Access Compliance Report Public Rights-of-Way (Curb Ramps)

Main Street: MADISON_AVE		Cross Street: HUNTER_LN		Location:	NW
ADA ID: RPRK220203152951	Ramp Type: Type 4 - Parallel	Initial Pass/Fail: Pass	Overall Compliance: No	Severity Score:	0
Codes/Mitigation Info/Possible Solution			Field Measurements/Component Compliance

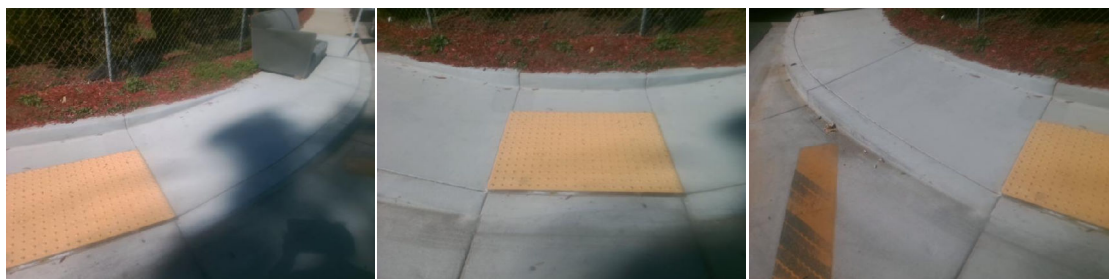
Compliance	Description	Data	Compliance	Description	Data
N/A	Ramp Length LT (in)	80	N/A	Ramp Length RT (in)	79
Yes	Ramp Width LT (in)	53	Yes	Ramp Width RT (in)	53
Yes	Ramp Run Slope LT (%)	6.4	Yes	Ramp Run Slope RT (%)	7.7
Yes	Ramp Cross Slope LT (%)	0.7	Yes	Ramp Cross Slope RT (%)	0.2
N/A	Landing Present	Yes	Yes	DWS Provided	Yes
N/A	Landing Length (in)	53	Yes	DWS Contrast	Yes
Yes	Landing Width (in)	48	Yes	DWS Length (in)	36
No	Landing Run Slope (%)	2.2	Yes	DWS Full Width	Yes
Yes	Landing Cross Slope (%)	0.9		DWS Offset Type	Single
N/A	Landing Movement Obstructed?	No	Yes	DWS Offset Left (in)	0
	Landing Movement Type	Curb	Yes	DWS Offset Right (in)	N/A
N/A	Landing Shared	No			
N/A	Clear Space	Yes			
N/A	Clear Space To Crosswalk (in)	48			
N/A	Marked Crosswalk 1	No	N/A	Marked Crosswalk 2	Yes
	Crossing 1 Direction	S		Crossing 2 Direction	E
	Marked Crosswalk 1 Width (in)	N/A		Marked Crosswalk 2 Width (in)	144
N/A	Ramp Inside Crosswalk 1	N/A	Yes	Ramp Inside Crosswalk 2	Yes

Remove & Replace Landing.
